Project: **TOUCHSTONE VILLAGE CENTER**  
 for: **CROSLAND GROUP**  
 Sheet Title: **REZONING PLAN**

SUBJECT: Administrative Approval for Petition #90-13  
 Tax Parcel #223-025-02

SUBJECT: Administrative Approval for Petition No. 90-13 by Touchstone Assoc. Ltd. Partnership Tax  
Parcel # 223-025-02

SUBJECT: Administrative Approval for Petition No. 90-13 by Touchstone Associates Ltd. Partnership  
Tax Parcel # 223-025-02

Project Number  
2094-X4  
Sheet  
SP-1

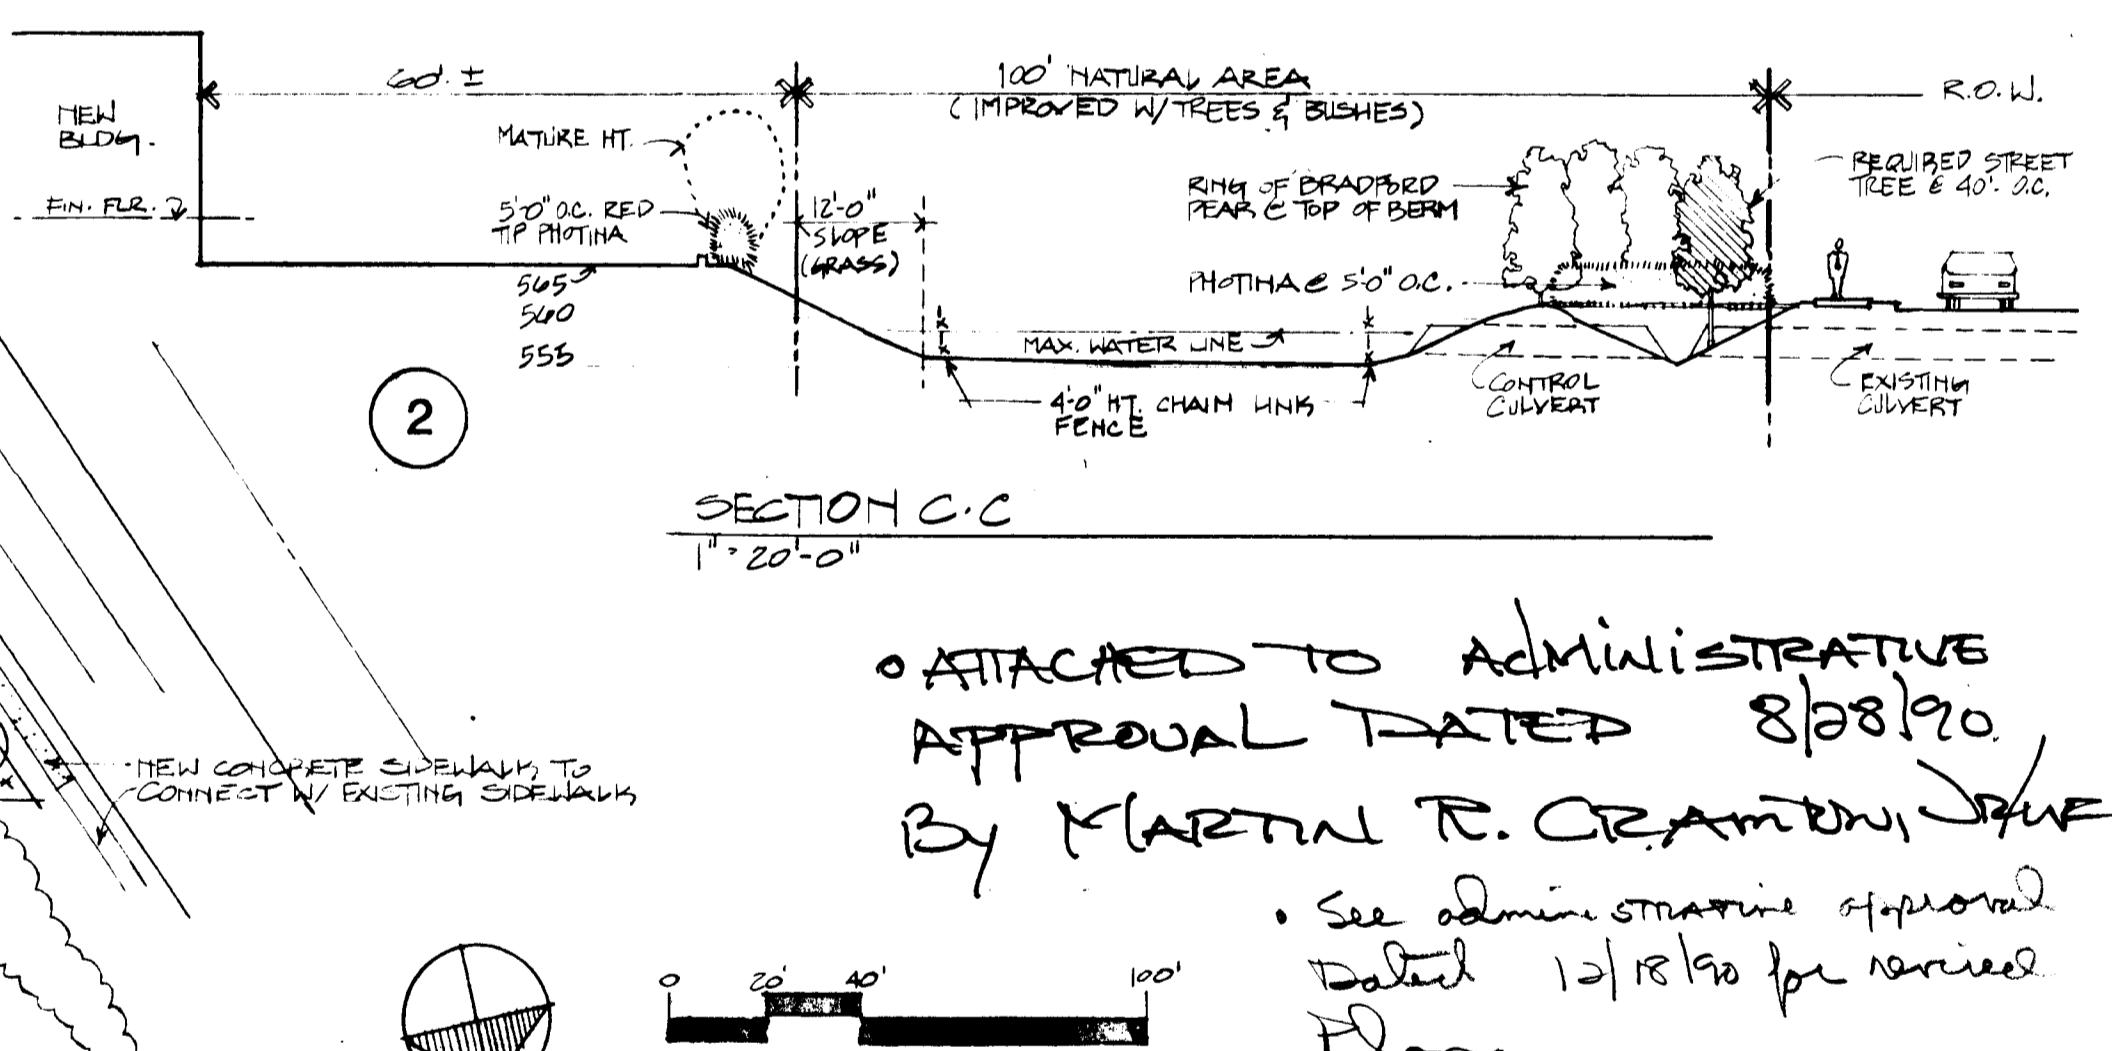
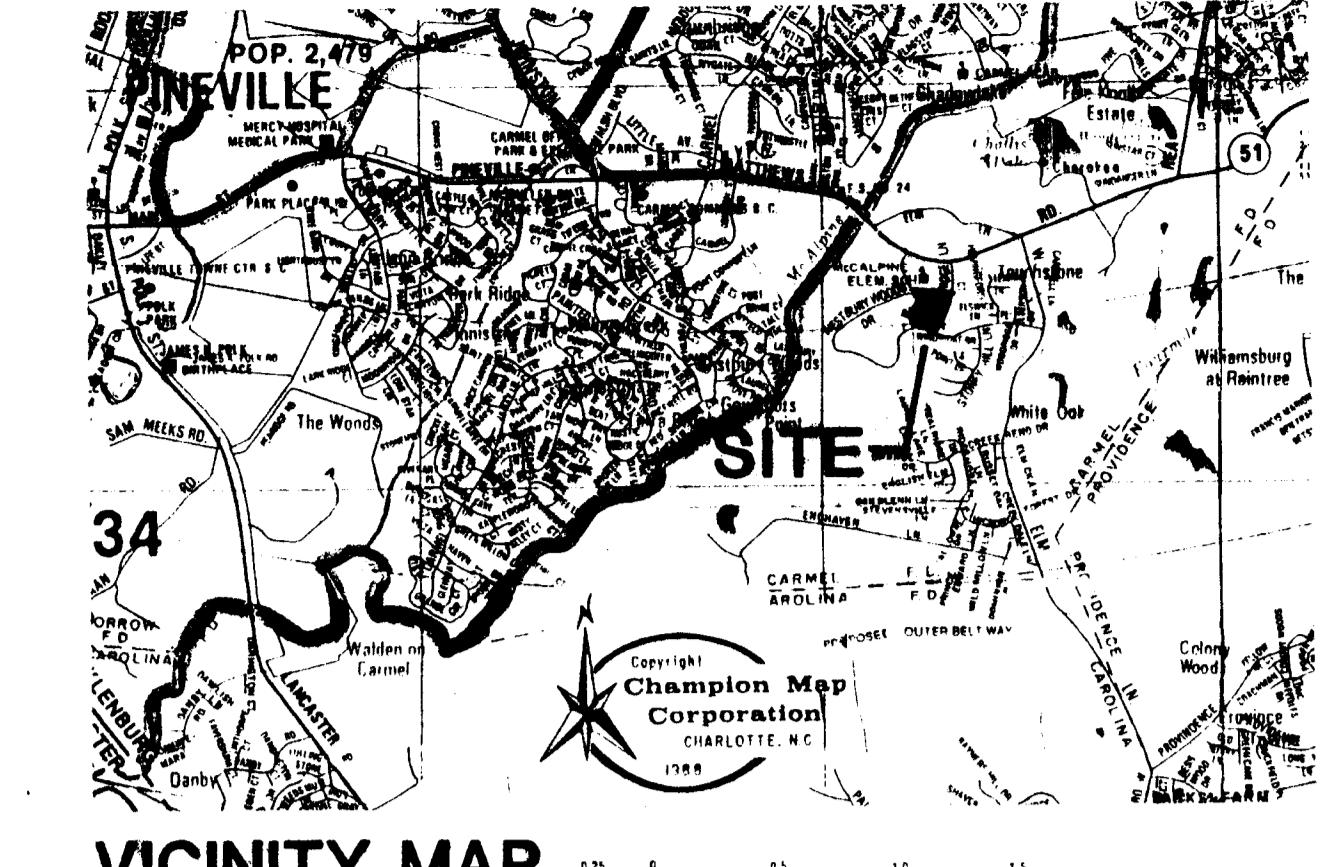
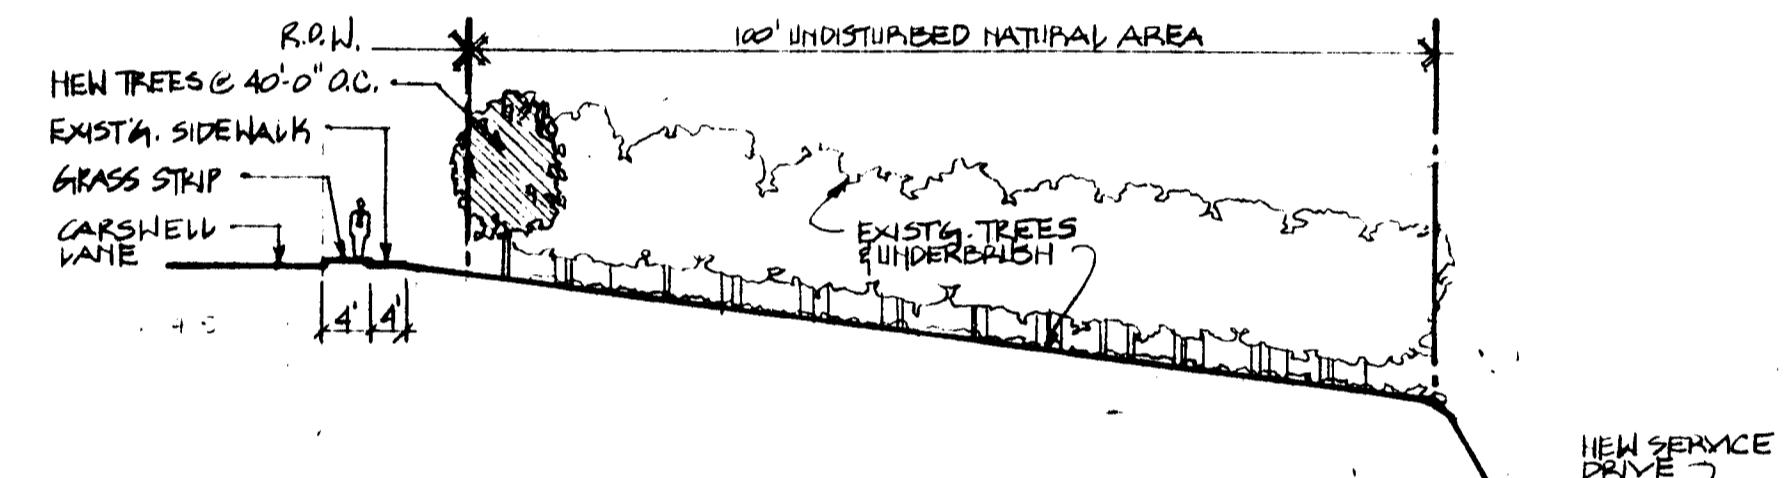
Attached is a revised plan for the above mentioned rezoning petition. The plan is being revised to show a new location for the project identification sign along Carswell Lane. The sign is being moved from the north side of the driveway to the south side of the driveway. This shift will allow the developer to save the trees between the driveway and the school property to the north.

Pursuant to the authority as outlined in the zoning ordinance, I am administratively approving this plan. Please use it when evaluating requests for building permits.

#### TOTAL SITE PLAN

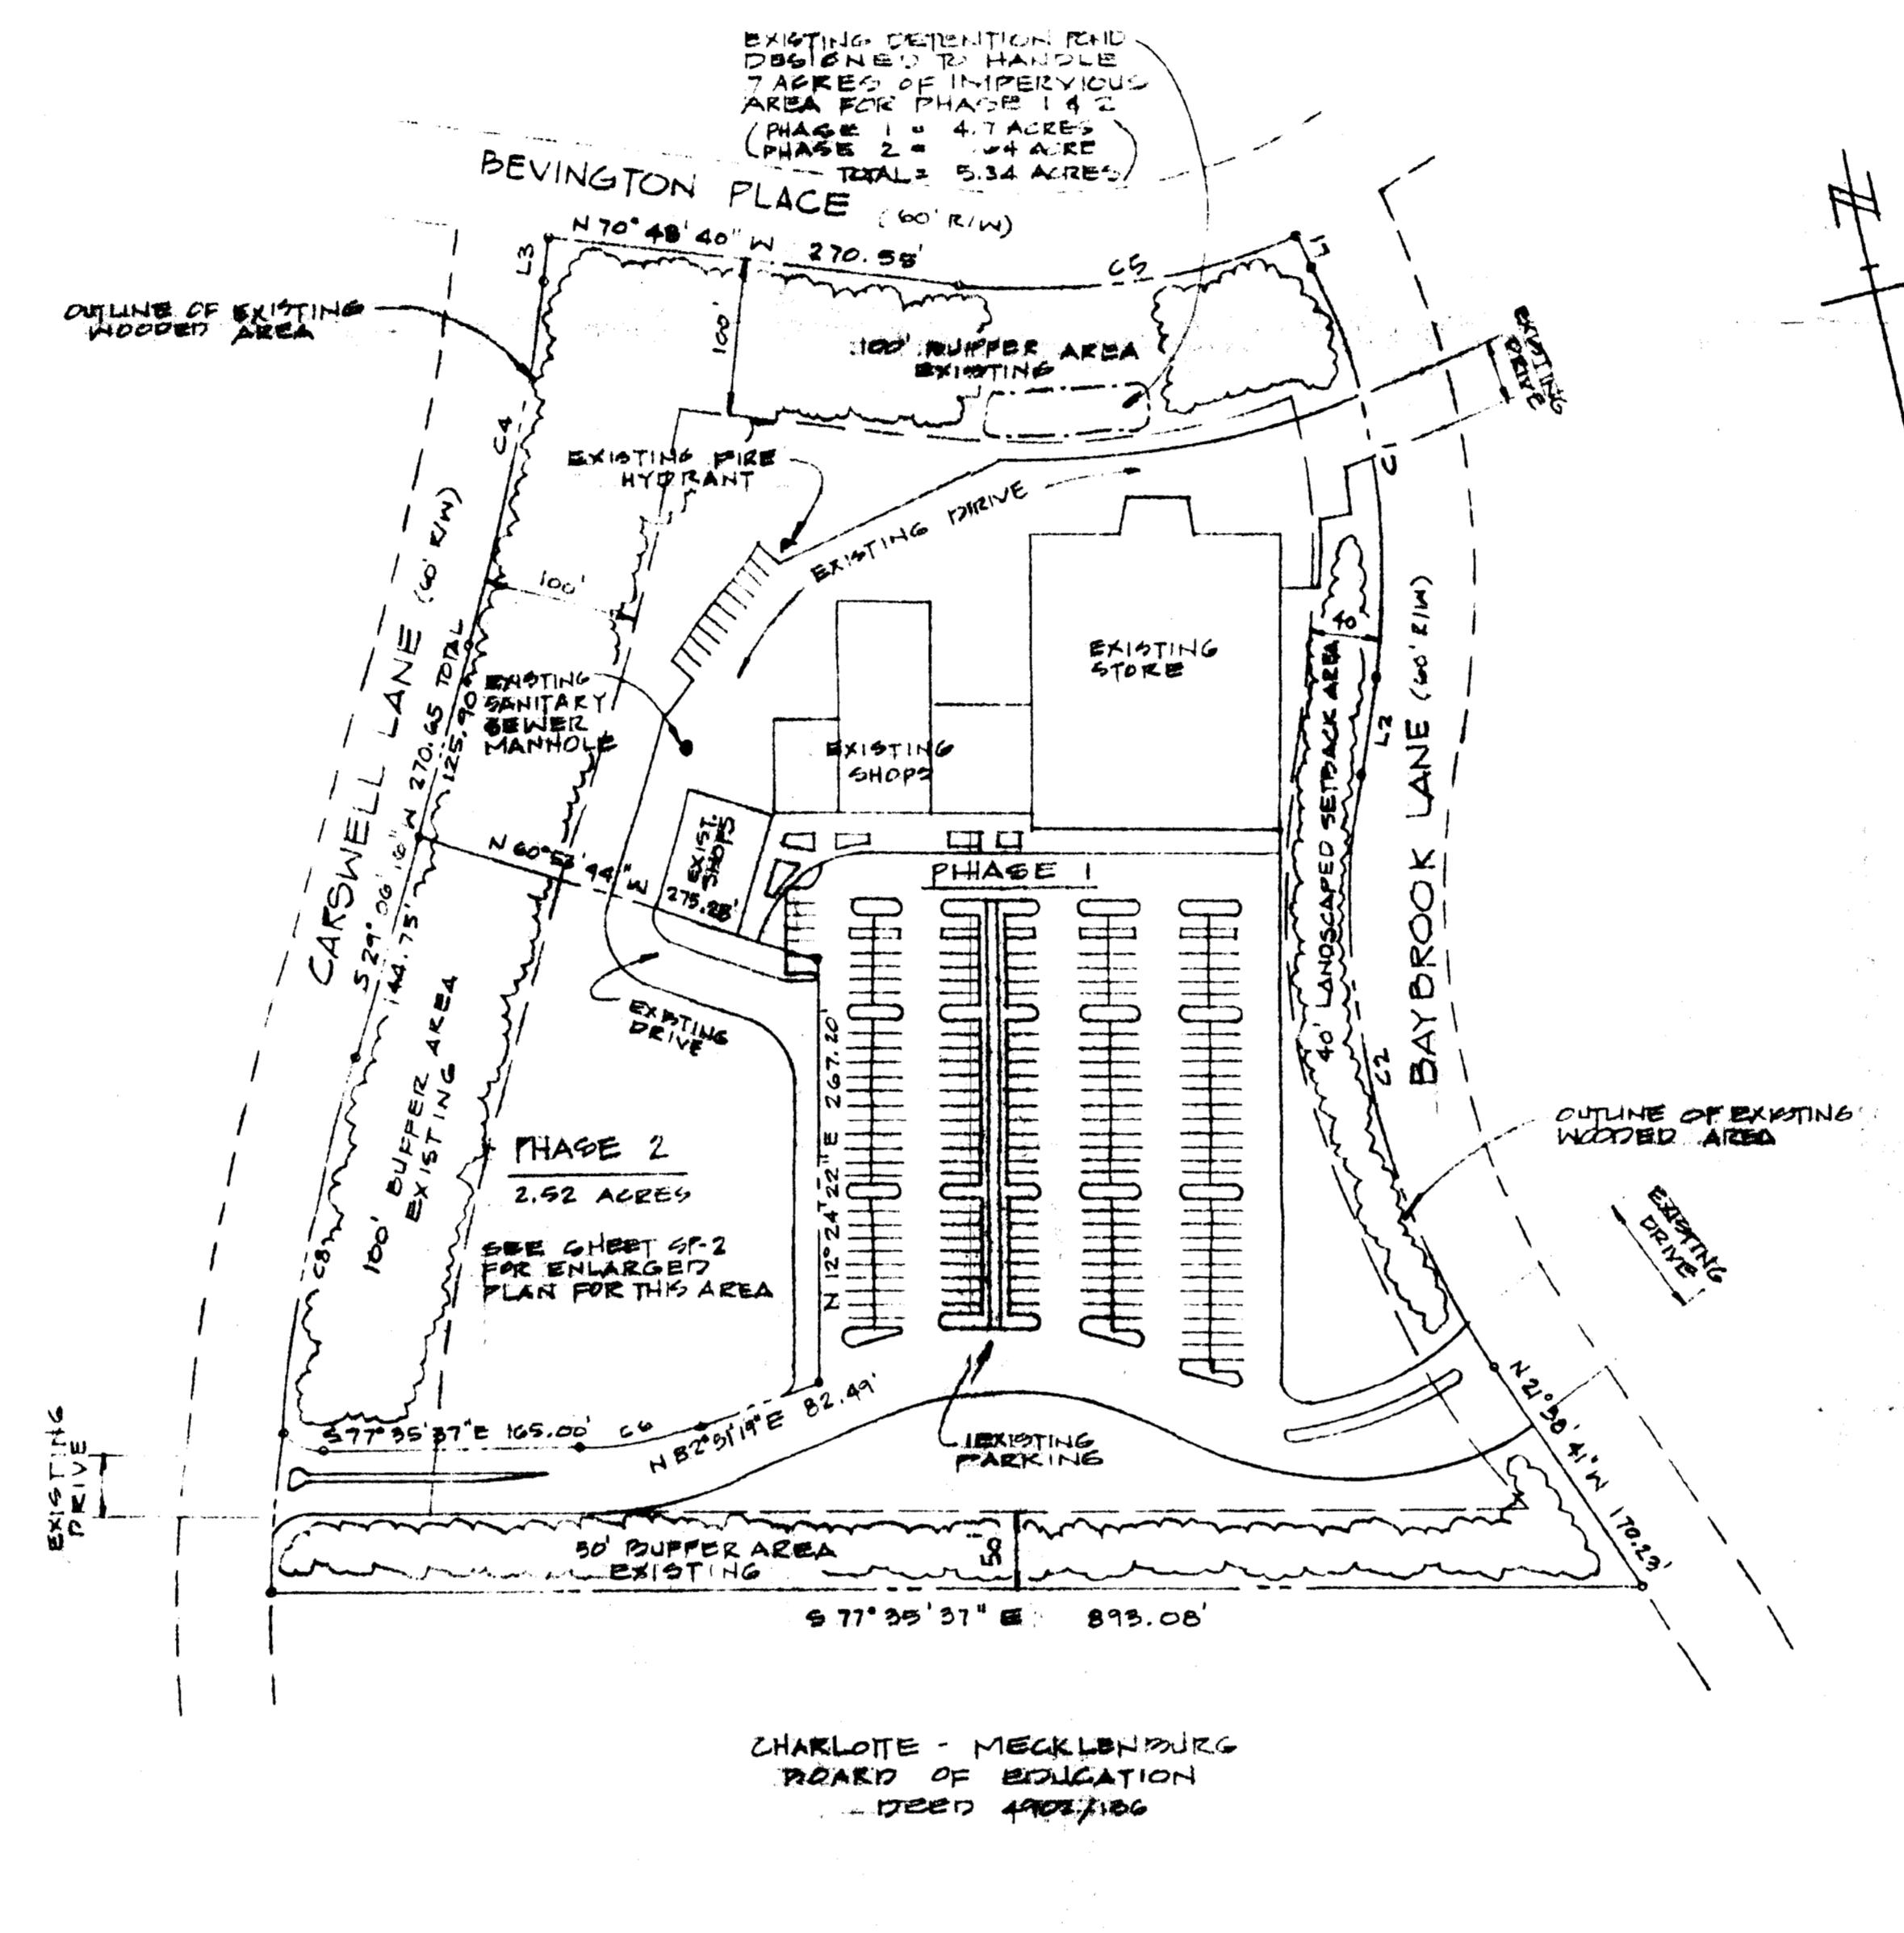
Attached is a revised plan for a phase two of the Touchstone Shopping Center showing the development of this phase with a day care center. The originally approved plan had shown the development of this phase with additional shop space. Since day care centers are allowed by B-1 zoning classification and the total square footage for the shopping center is not been exceeded we are administratively approving this revised plan. Please use this revised plan when evaluating requests for building permits and certificates of occupancy.
